CITY OF AUSTIN
Board of Adjustment/Sign Review Board
Decision Sheet

CASE NUMBER: C15-2014-0050

ADDRESS: 1190,1192,1194,1196,1198 NAVASOTA ST

VARIANCE REQUESTED: The applicant has requested a variance from Section 25-2-779 (G) of Small Lot Single- Family Residential Use standards to decrease the rear through lot setback from 15 feet to 10 feet on the Waller Street property line; and from Section 25-2-779 (I) to decrease one of the interior side yard setbacks on each lot from 3.5 feet to 1 foot in order to construct a single family home and AC unit in an "CS-MU-CO-NCCD-NP", Commercial Services - Mixed Use - Conditional Overlay - Neighborhood Conservation Combining - Neighborhood Plan (lots 1-3) and "CS-MU-CO-NP", Commercial Services - Mixed Use - Conditional Overlay - Neighborhood Plan (lots 4-5) zoning district. (Central East Austin)

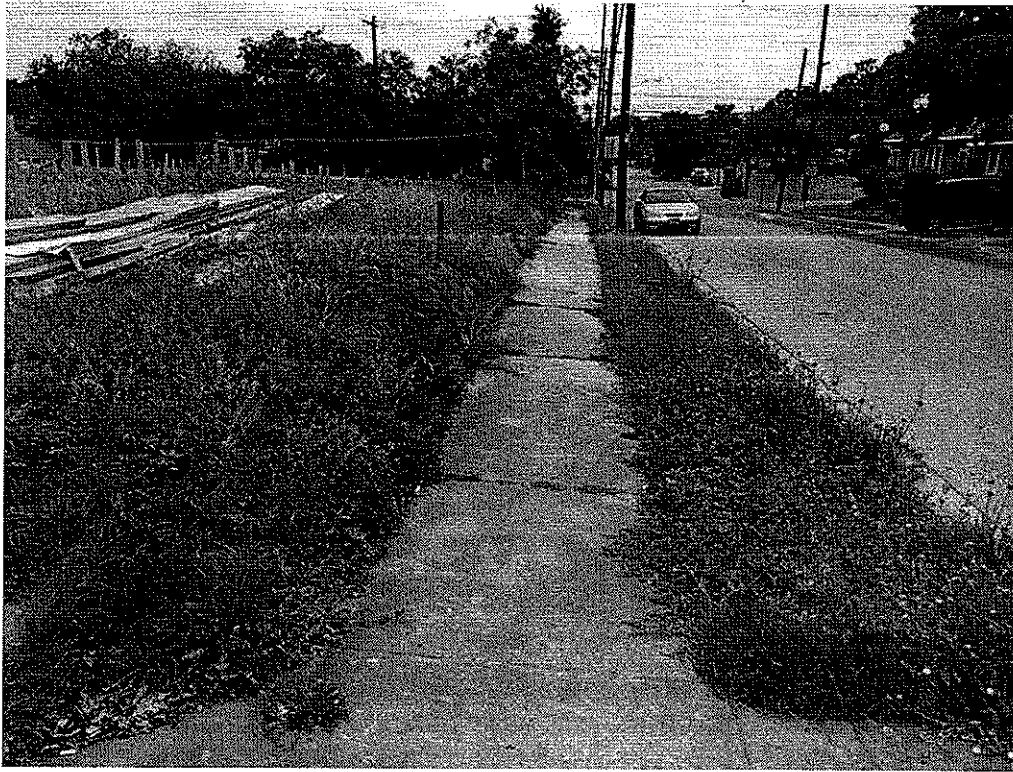
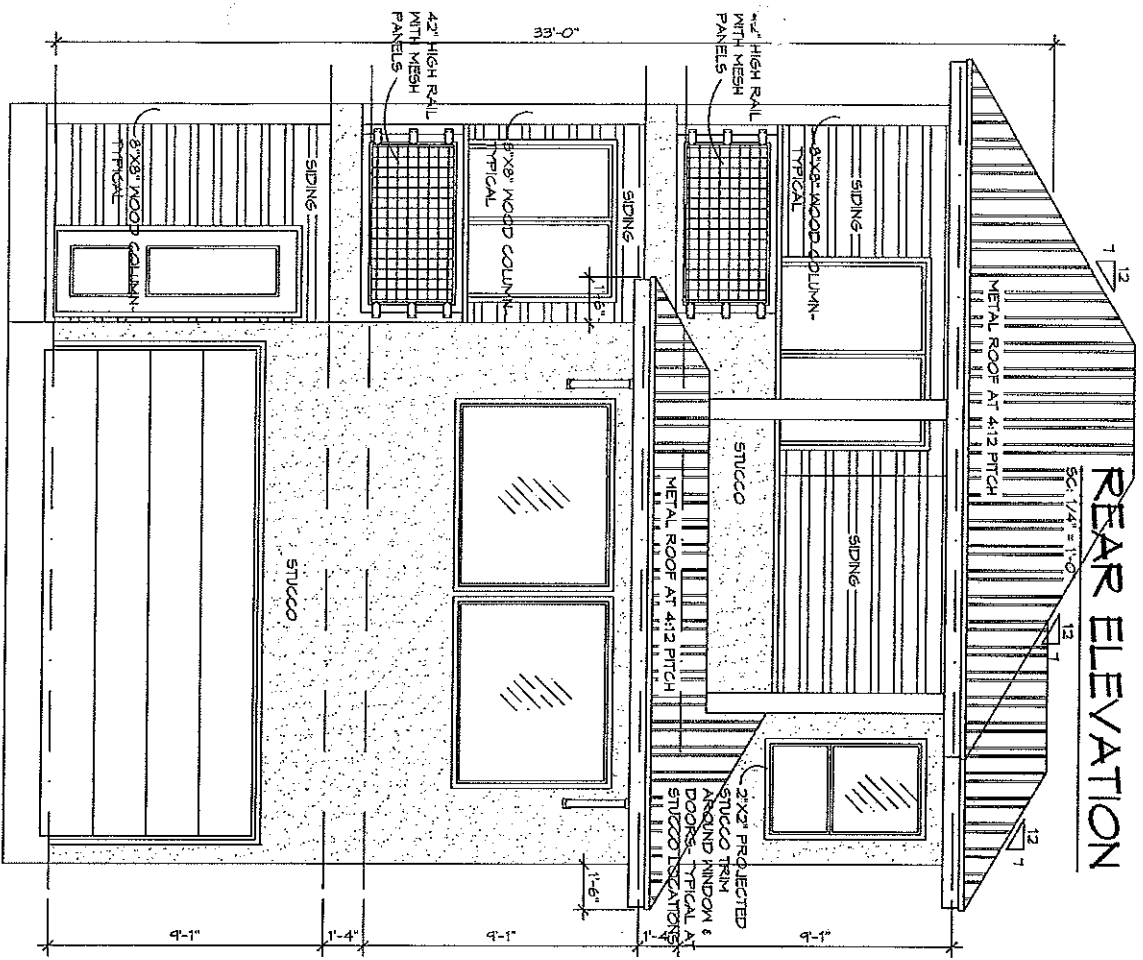
Approximately 20' from curb (10' building line?)

Forms set at 25' from curb (15' building line)

Subdivision	Anderson Hill
Lot	5
Block	B
Address	1191 Waller St.
Plan Number	#4-1128
Date	11.21.13

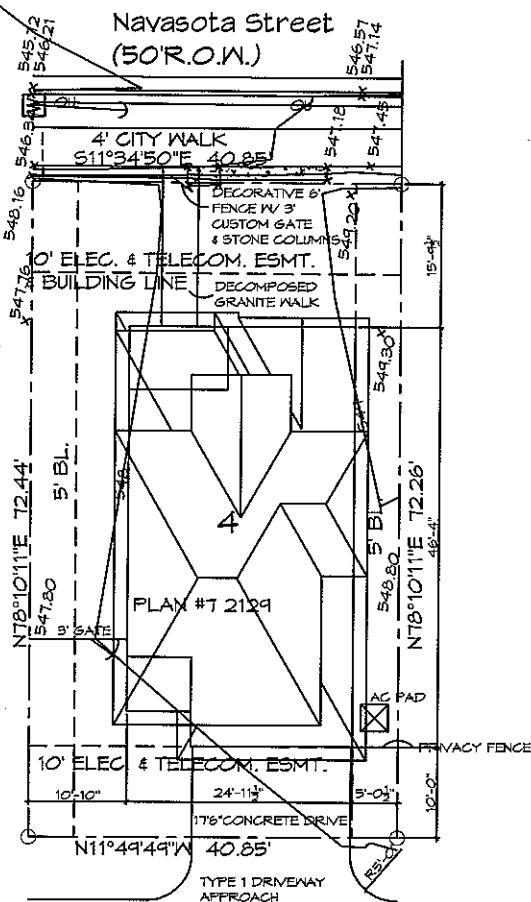
- ① Subject property is a through lot and per LDC 25-2-515 – the rear yard setback is the same as the front yard setback. In addition, per LDC 25-1-21 (41) - a front line for a through lot is the lot line abutting the street that provides the primary access to the lot. The setbacks for this property are 15 feet for both the front and rear yard setbacks, 10 feet for a street side yard setback, and 5 feet an interior side yard setback.

- ③ The plot plan submitted and proposed building footprint does not comply with the required setbacks for this property. The garage is encroaching into the front yard setback. Plans will have to be revised or the applicant must seek a Board of Adjustment Variance. 25-2-779

4. The property has multiple 10 foot easement (electric and telecom) lines along the property lines adjacent to the adjacent Right-of-Ways. The plot plan must be revised to correctly depict and label the existing 10 foot easements as platted and recorded with the Anderson Hill Subdivision.

5. No encroachments of structures (which includes eaves and roof overhangs) are allowed within the 10 feet (electric and telecom) easements on the subject property. Plans must be revised and approved by Austin Energy prior to Final Approval of this Plan Review.
